**ERRATA TO THE
DOWNTOWN COLLEGE PREPRATORY RELOCATION PROJECT
INITIAL STUDY/MITIGATED NEGATIVE DECLARATION**

FILE NO.: CP16-013

LOCATION OF PROPERTY 1402 Monterey Road, at the southwesterly corner of East Alma Avenue and Monterey Highway (APN: 477-07-012)

FIGURE 3.2-5 [REVISED]

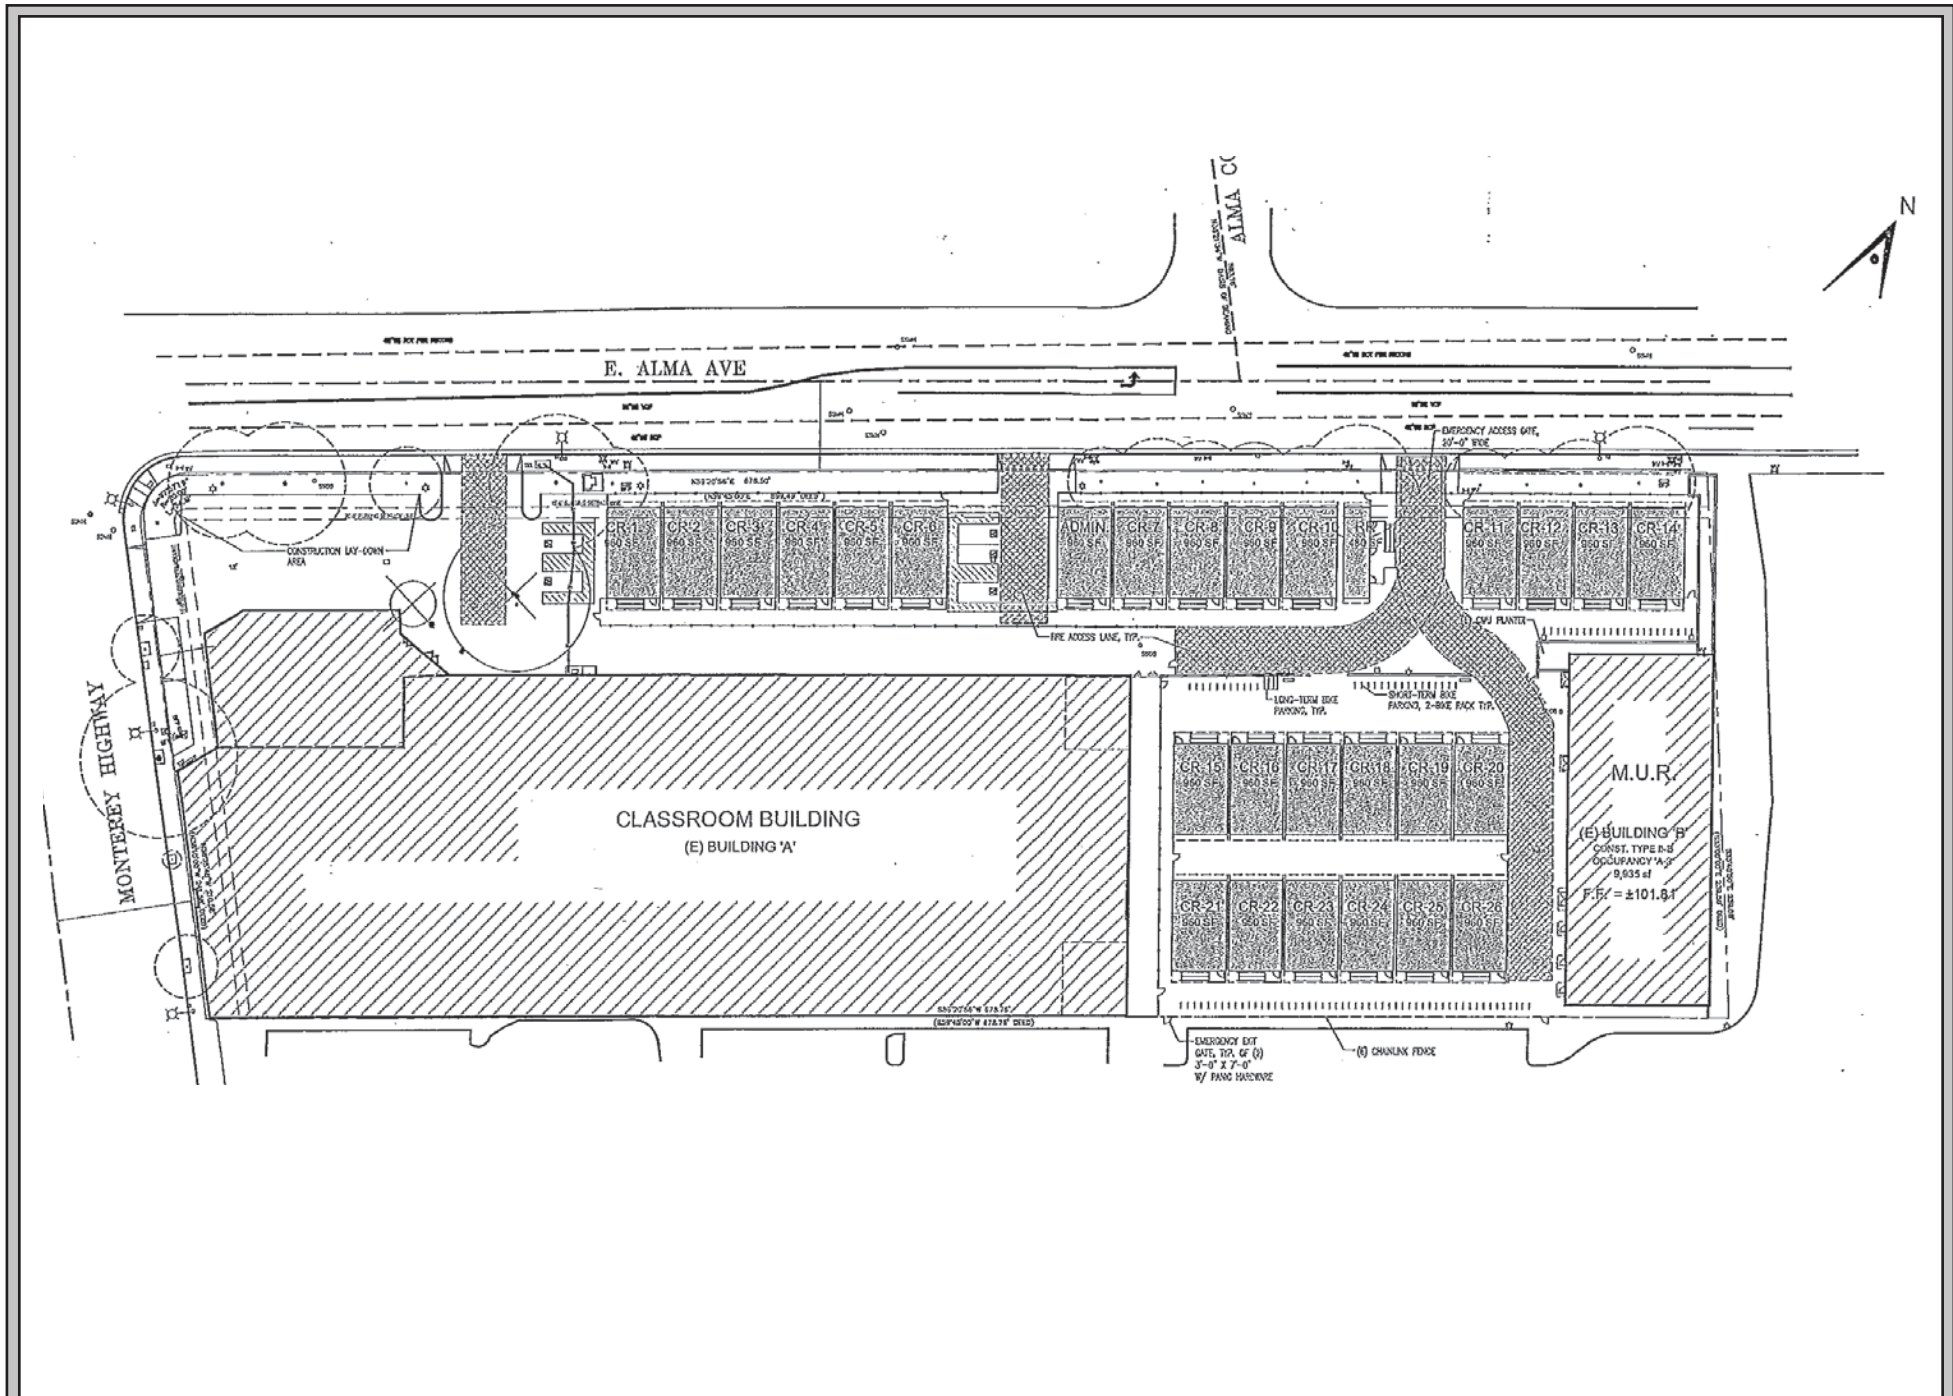
Figure 3.2-5 (page 13):

Figure 3.2-5 has been revised. The revised figure is attached.
